# UNITED STATES PATENT AND TRADEMARK OFFICE

APPLICATION NO.	FILING DATE	FIRST NAMED INVENTOR	ATTORNEY DOCKET NO.	CONFIRMATION NO.
10/506,287	08/31/2004	Henricus Marinus Josephus Hikspoors	NL 020186	6744

## Office Action Summary

3. **Claims 1-8 and 10 are rejected under 35 U.S.C. 103(a) as being unpatentable over Swanson et al., (Swanson), USPAT 5,889,567 in view of Weber et al., (Weber), USPAT 6,025,897 and Moon et al., (Moon), USPAT 6,882,386.**

FIG 19

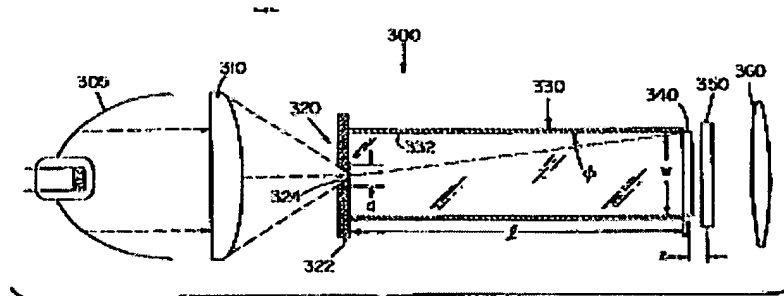
4. Swanson discloses and shows in Fig. 19, a projection device for projecting an image comprising a light source (305) for emitting light, a transmissive LCD projection subsystem and a projection means (360) for projecting the image, the projection subsystem comprising:

- a waveguide integrator (330) for guiding light from an entrance to an exit, the inner entrance surface of the integrator being coated with a reflective material

(322) and having a hole (324) for coupling light emitted from the light source into the integrator; and

- a transmissive LCD (350) provided at the exit side of the integrator.

Swanson differs from the claimed invention because he does not explicitly disclose the claimed reflective polarizer at the exit surface of the integrator.

As to claim 5, Swanson shows in Fig. 19 that the waveguide integrator further comprises retardation film (340) for changing the polarization of the polarized light back into the integrator.
